Arlington Historic District Commissions

Application for Certificate

Installation of a red cedar privacy fence along the property line of 221 Pleasant St and 231 Pleasant St extending from the property boundary on Pleasant St for a distance of 116 linear feet.

221 Pleasant St. Fence Proposal

view of 221 - 231 property line from above 221 property - derelict fence can be seen on right side of photo

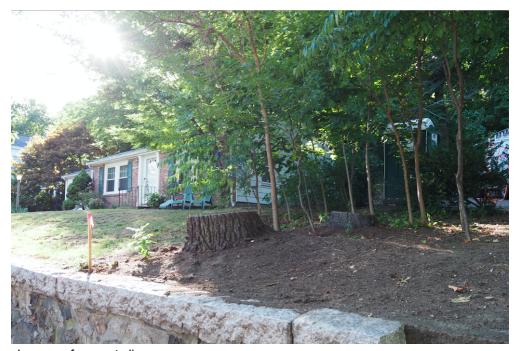
It looks complete except a photo of the current conditions might help explain the story a bit better.

The Commissioner reviewing the applications for the upcoming meeting has said a photo of the current conditions might help explain the story a bit better to the Commissioners. Can you submit one for the record? Thanks - Carol Greeley

No problem - attached are some photos from the public street view of the property line between our house 221 and the neighbor 231 Pleasant. I also included a photo that shows the property line with the derelict fence that the neighbor subsequently removed a couple of weeks ago. Please let me know if there are any specific views you would like as I can go to the house and take some shots.
